INCH-POUND
MIL-PRF-55310/26A
AMENDMENT 1
3 July 2000

PERFORMANCE SPECIFICATION SHEET

OSCILLATOR, CRYSTAL CONTROLLED, TYPE 1 (CRYSTAL OSCILLATOR (XO)), 10 kHz THROUGH 65 MHz, HERMETIC SEAL, SQUARE WAVE, HIGH SPEED CMOS

This amendment forms a part of MIL-PRF-55310/26A, dated 25 March 1998, and is approved for use by all Departments and Agencies of the Department of Defense.

FIGURE 2. Load test circuit.”

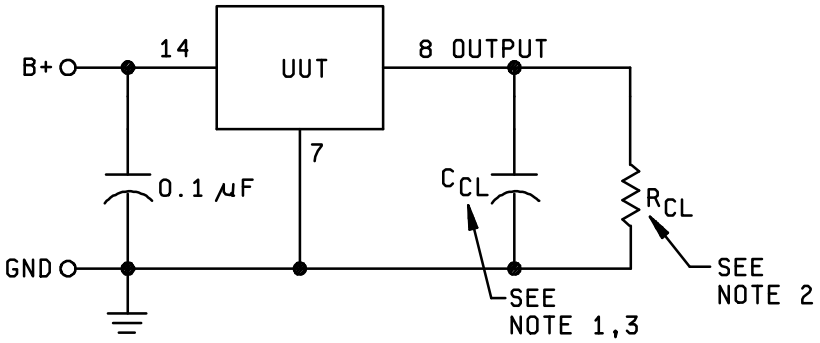
Figure 2, delete and substitute:

NOTES:
1. For HCMOS: C_{CL} = 15 pF ±5 percent.
2. For HCMOS: R_{CL} = 10 kΩ ±5 percent.
3. C_{CL} includes scope capacitance.
